## SAMPLE REPRESENTATIVE OF PRODUCTION

### DECLARATION OF DIFFERENCES

Model No.: DVD-LX95

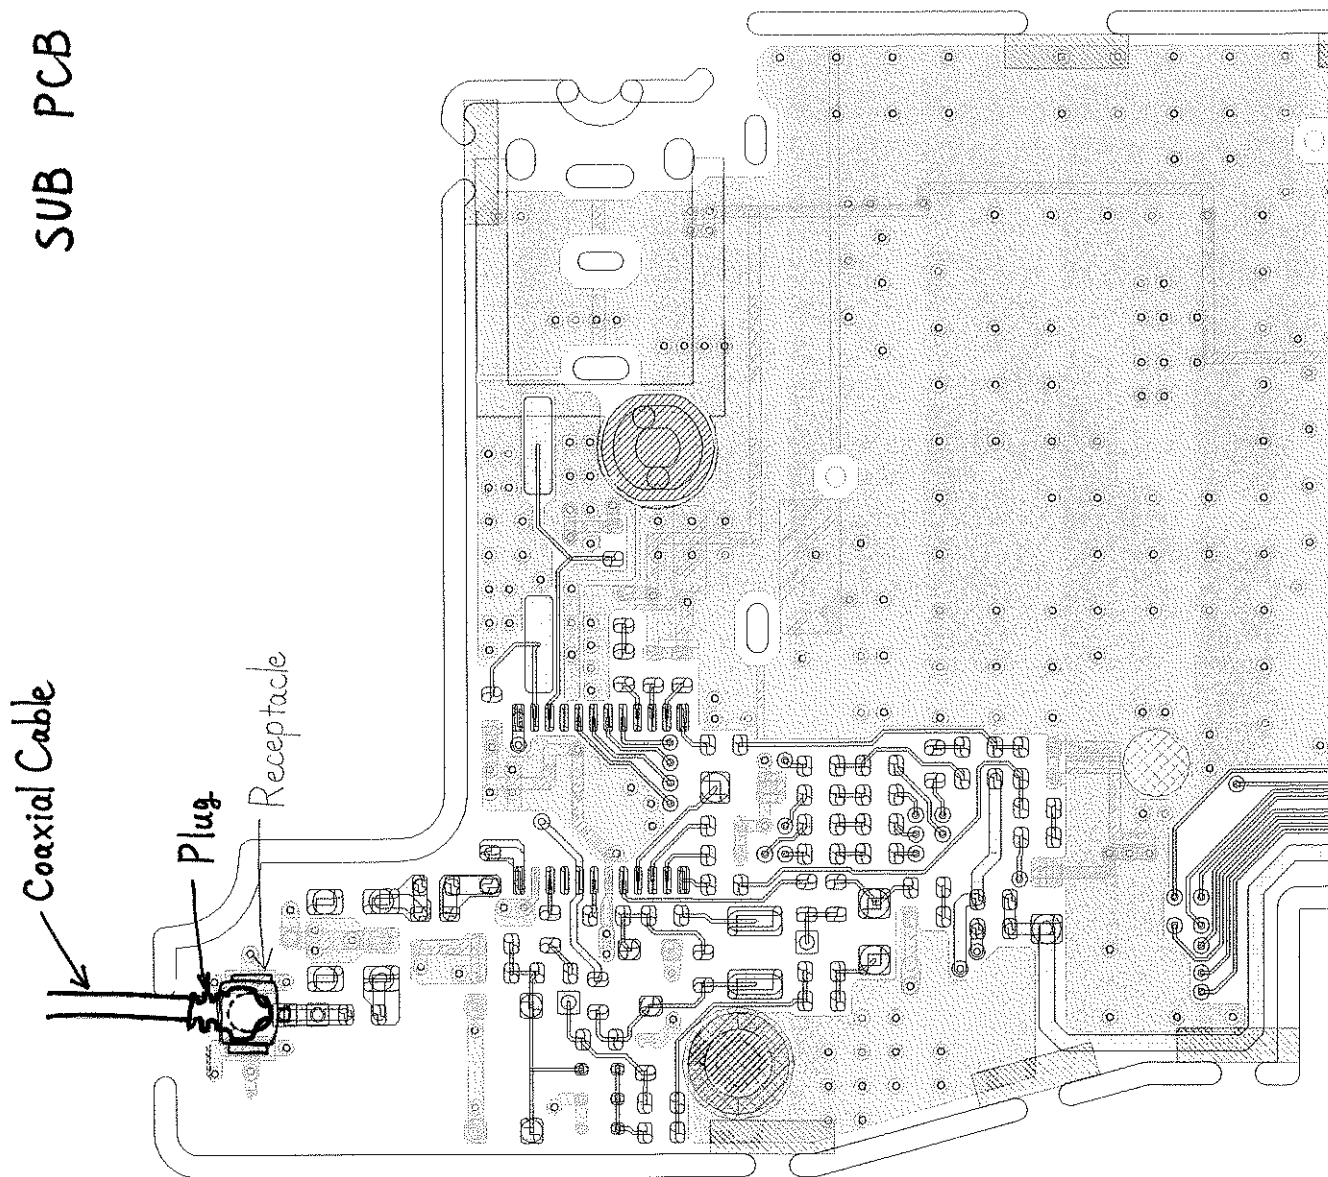
| Substitute<br>Features                                             | Details of Differences                                                                                                                              |                                                                                                                                                                                                                                                                                                                      |
|--------------------------------------------------------------------|-----------------------------------------------------------------------------------------------------------------------------------------------------|----------------------------------------------------------------------------------------------------------------------------------------------------------------------------------------------------------------------------------------------------------------------------------------------------------------------|
| Connection method of<br>Coaxial Cable of FM<br>Transmitter Antenna | <p>1. Coaxial Cable with Plug.</p> <p>2. Receptacle (connector) on PCB.</p> <p>3. Coaxial Cable and PCB is connected<br/>by Plug and connector.</p> | <p>1. Coaxial Cable without Plug.</p> <p>2. Without Receptacle (connector) on<br/>PCB.</p> <p>3. Coaxial Cable is soldered to PCB<br/>directly.</p> <p>Please refer to the drawing of sample<br/>representative and production.</p> <p>This method will be implemented by<br/>running change in mass production.</p> |
